BCA Assessment Report

Elizabeth Enterprise Precinct
Industrial Facility (WH6)

Mirvac

Revision 3

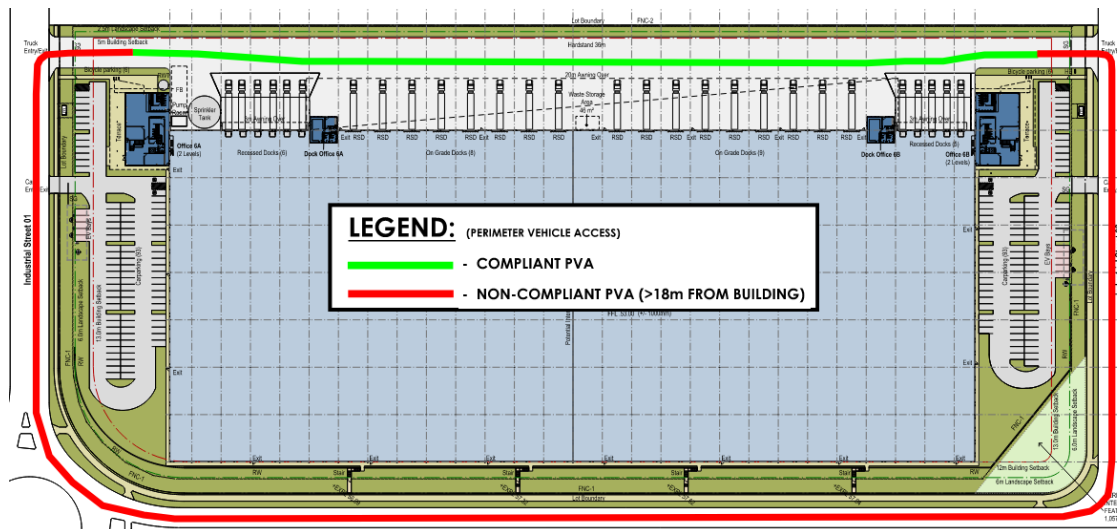
Comment: The perimeter vehicular access to Warehouse 6 deviates from the above requirements as follows:

- + Greater than 18m from the external walls in the areas highlighted in red.
